SSDA REPORT

North Sydney Public School 182 Pacific Highway, North Sydney NSW 2060

Report Prepared for: Department of Education
Report Prepared by: Lucy Alderson
Our Ref: AN021-216878 SINSW
Date: 27 August 2021

1 ELEVATION
BUILDING J - WEST ELEVATION
SCALE: 1:100

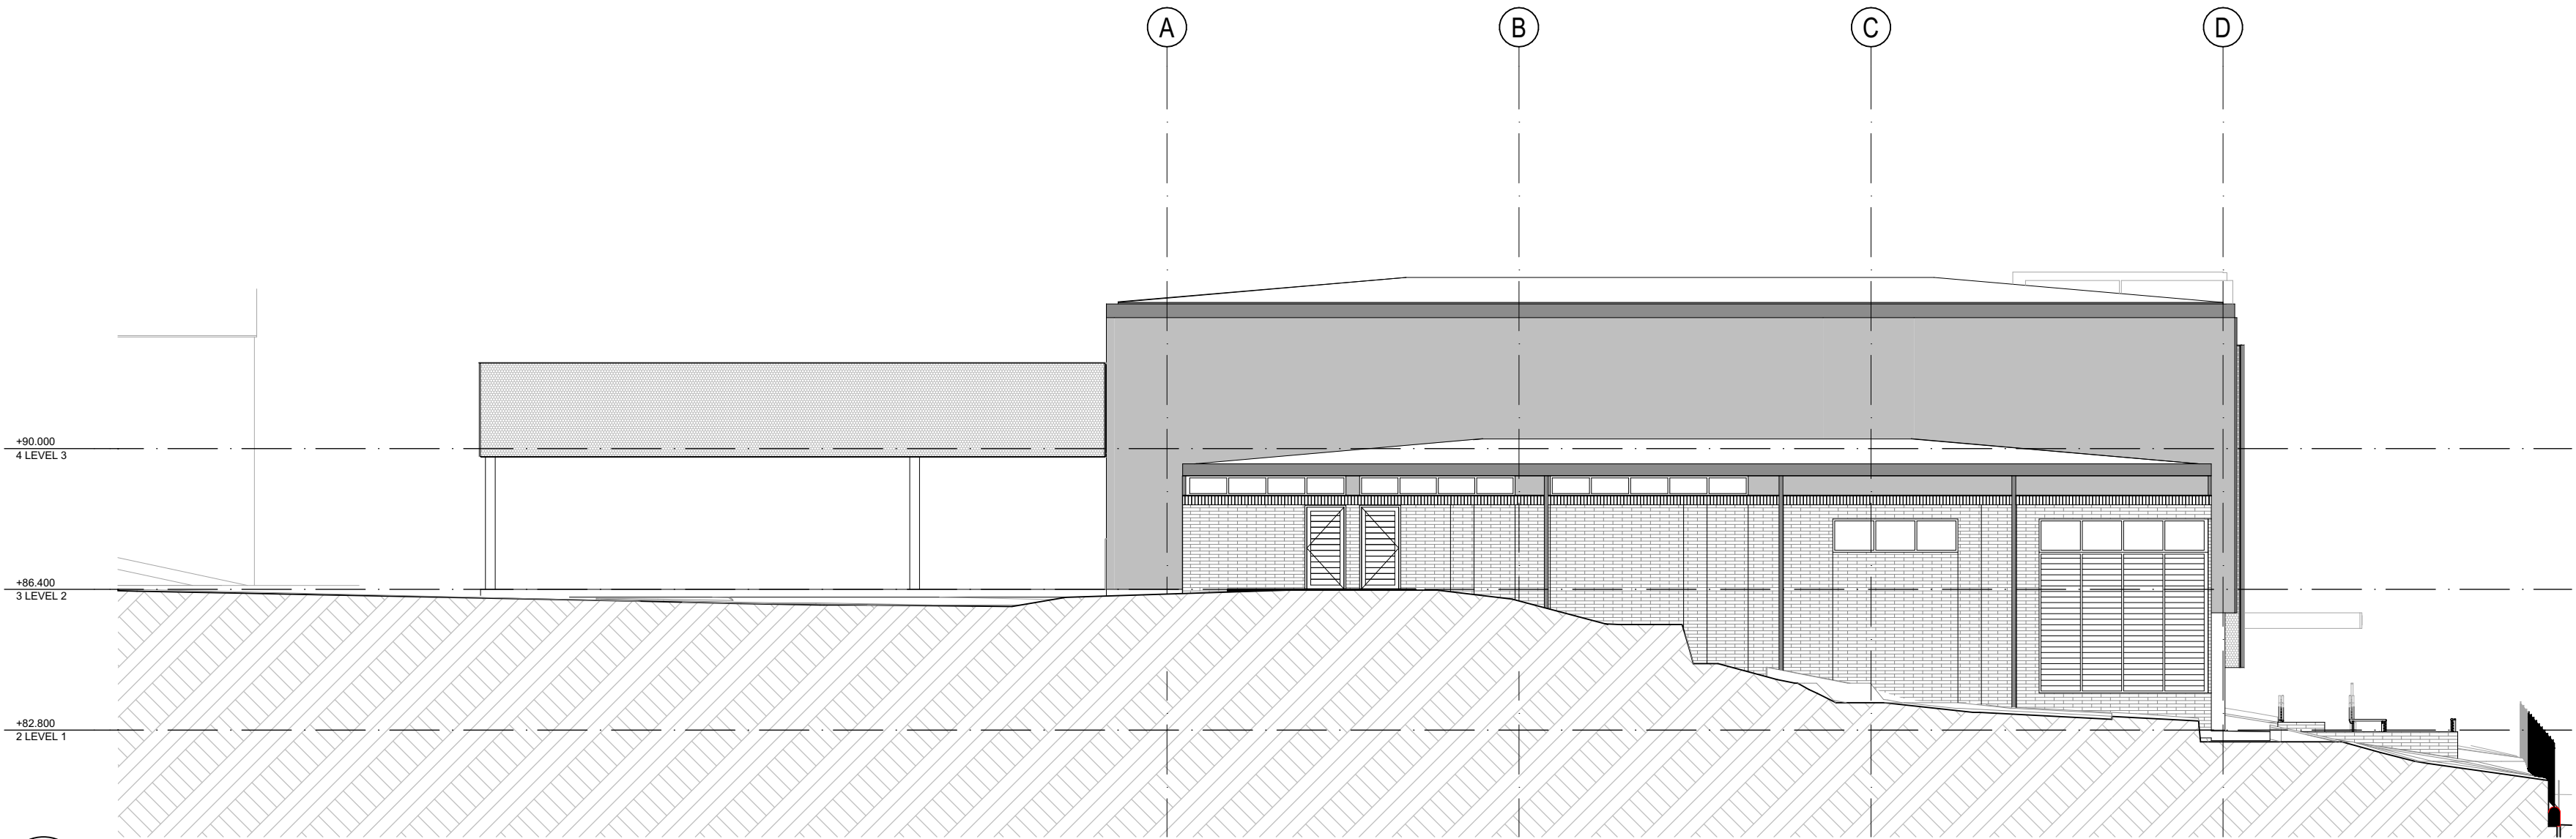
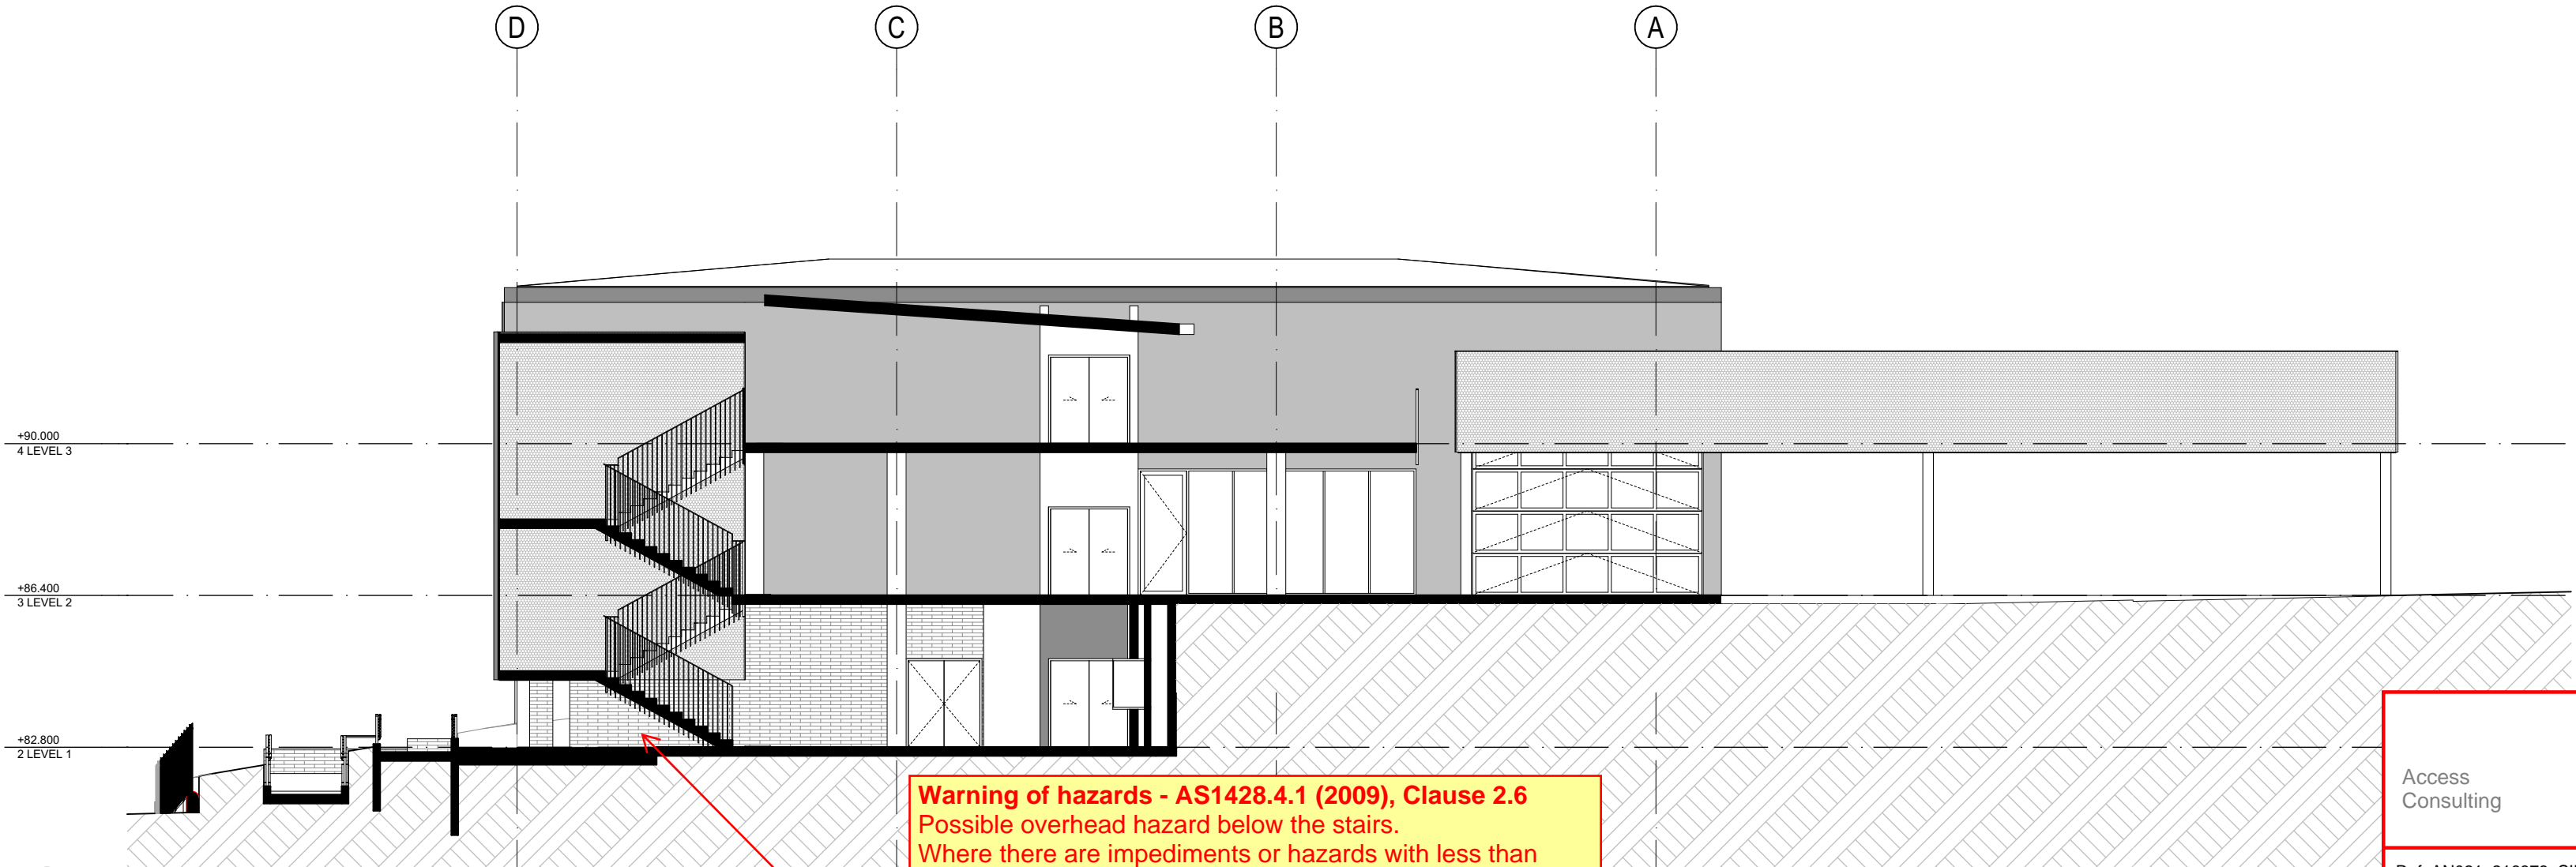
Warning of hazards - AS1428.4.1 (2009), Clause 2.6
Possible overhead hazard below the stairs.
Where there are impediments or hazards with less than 2000mm height clearance in an accessible open public space with no clearly defined continuous accessible path of travel, contact with overhead hazard shall be prevented by a suitable barrier complying with AS/NZS 1428.4.1 (2009), Clause 2.6(a)(b) and Figure 2.6(A)(B).

1 ELEVATION
BUILDING I - EAST ELEVATION
SCALE: 1:100

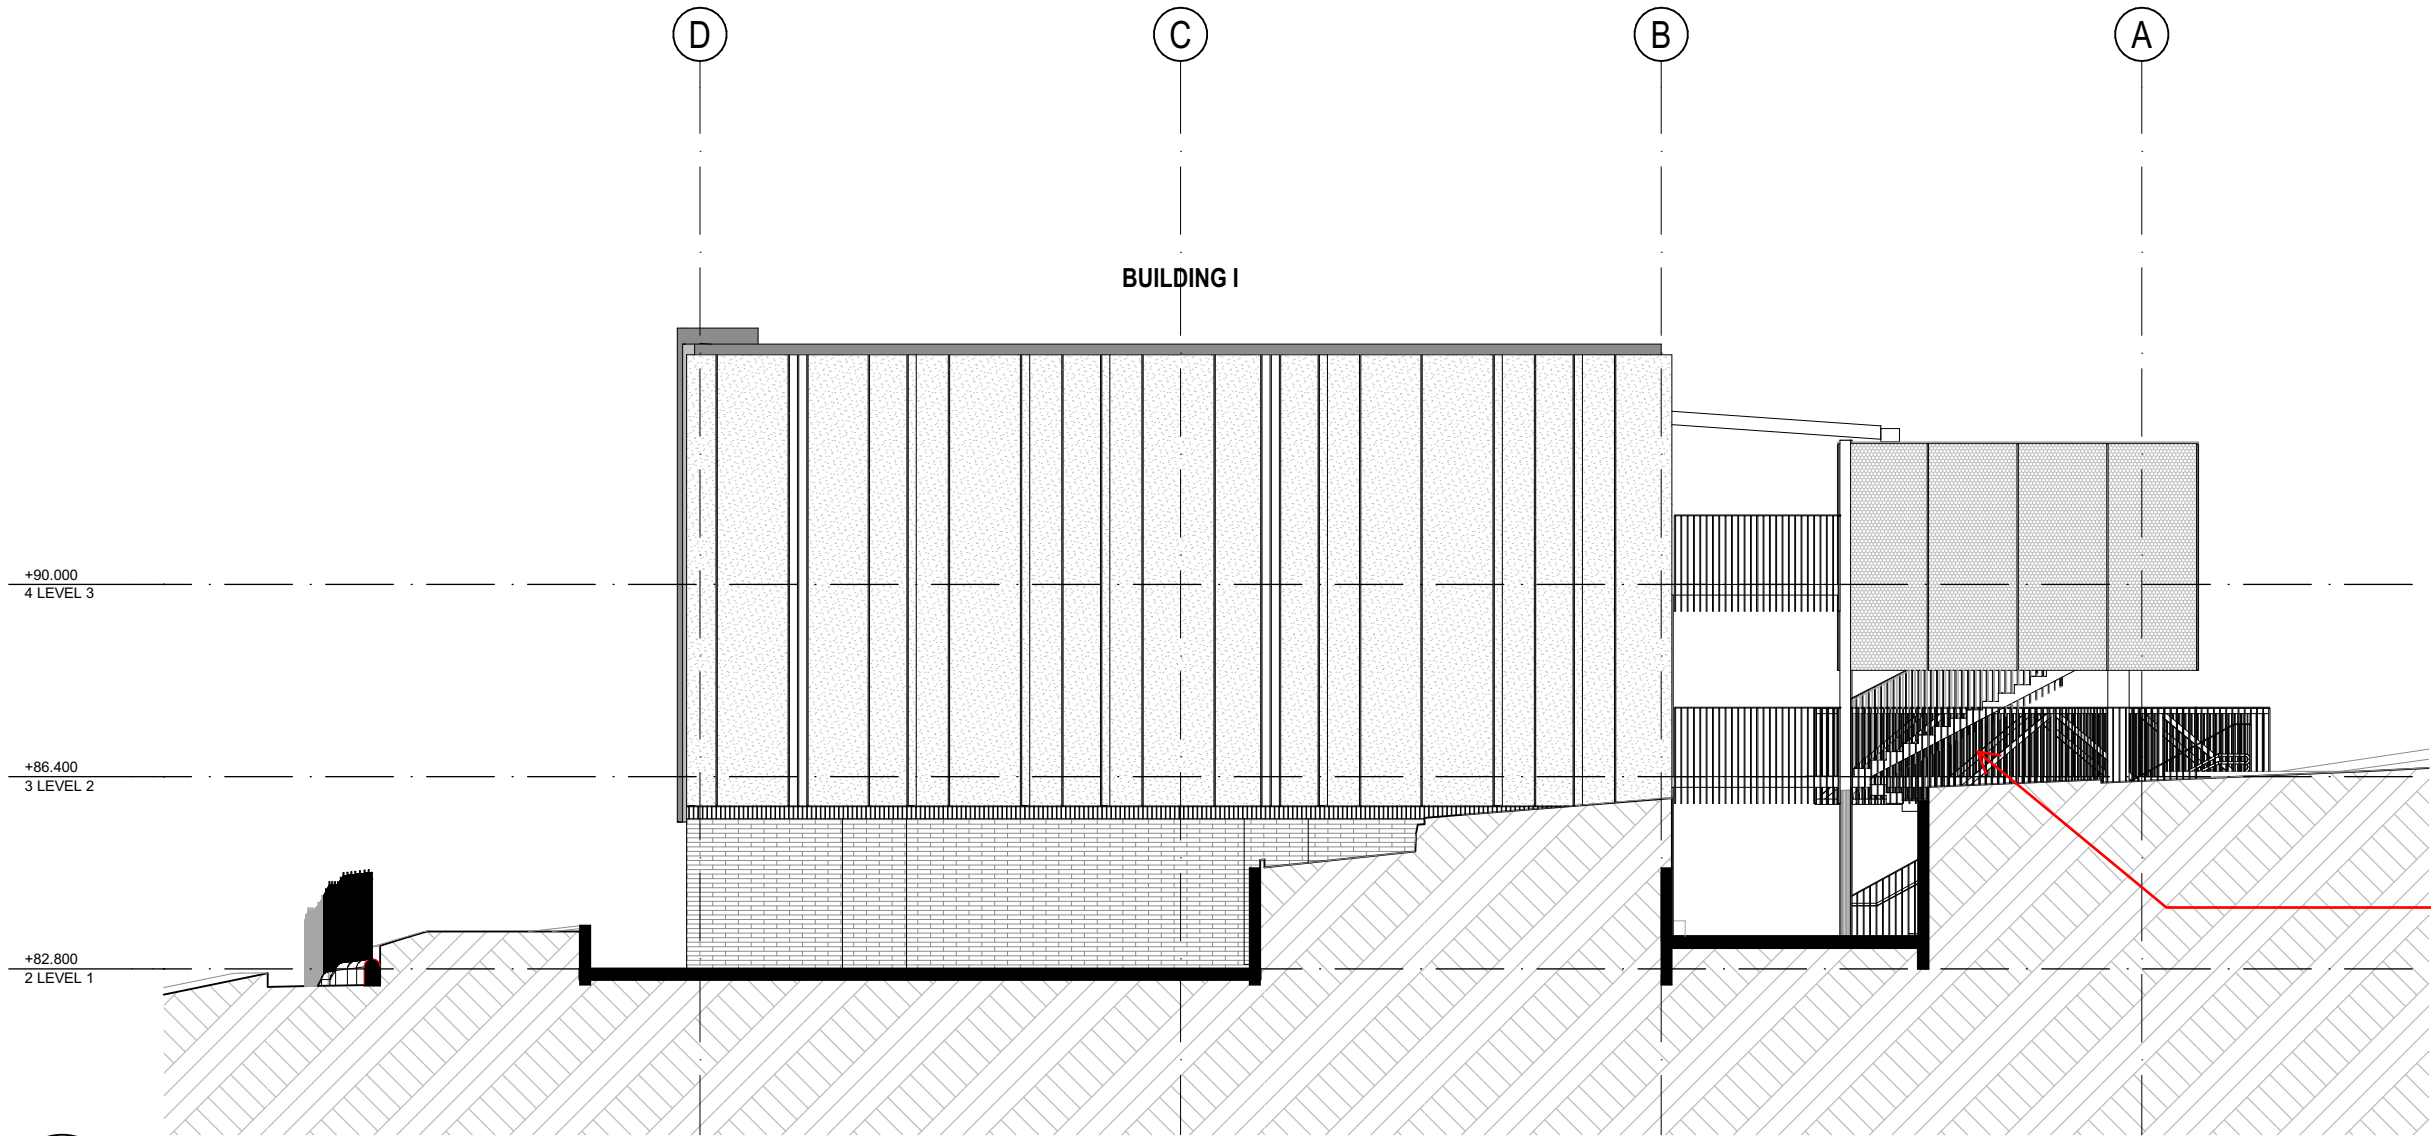
Warning of hazards - AS1428.4.1 (2009), Clause 2.6
Possible overhead hazard below the stairs.
Where there are impediments or hazards with less than 2000mm height clearance in an accessible open public space with no clearly defined continuous accessible path of travel, contact with overhead hazard shall be prevented by a suitable barrier complying with AS/NZS 1428.4.1 (2009), Clause 2.6(a)(b) and Figure 2.6(A)(B).
